# Ballard Pump Station

## Meeting Summary

This was the Seattle Design Commission's (SDC) first review of the Ballard Pump Station project. The purpose of this meeting was to review the concept design phase. After the presentation and discussion, the SDC voted 6-3 to approve the concept design phase for Ballard Pump Station project with several conditions and recommendations.

Figure 2: Proposed site plan

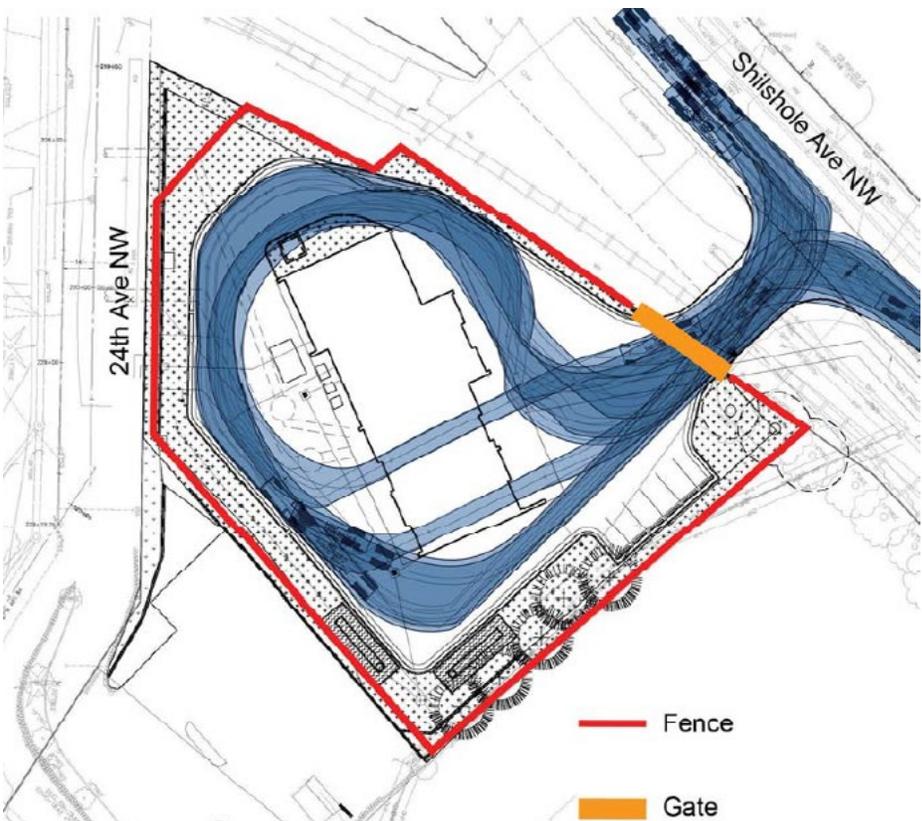
To reduce the amount of impervious surface on the site and to increase the efficiency of the site, the commission recommended that the project team explore alternative circulation options that would not require trucks to circle around the entire site. The Commission thought this could be achieved by having an additional curb cut on 24th Ave NW and maintaining the curb cut proposed on Shilshole Ave NW with a driveway along the east side of the site to connect the two curb cuts. Commissioners indicated that this type of solution would still allow access for semi-trucks and firetrucks that need to access the site annually and reduce the amount of impervious surface. Commissioners also recommended the design team consider rotating the facility footprint to accommodate alternative circulation patterns as well as a greater amount of publicly accessible space. See figure 4 for more detail

The SDC encouraged the design team limit security fencing to only areas that needed to be secured rather than fencing the entire perimeter of the site. Commissioners recommended the exterior of the building be accessible to community members.

1. Reduce the amount of security fencing and vegetated screening needed in order to increase the visibility of the building within the surrounding urban context. Limit fencing to only areas that need to be secured to increase public access to the site
2. Coordinate with appropriate agencies in addressing public improvements that will occur on 24th Ave NW, including the pier to the south, and Burke-Gilman Trail completion
3. Provide educational and cultural engagement opportunities on site
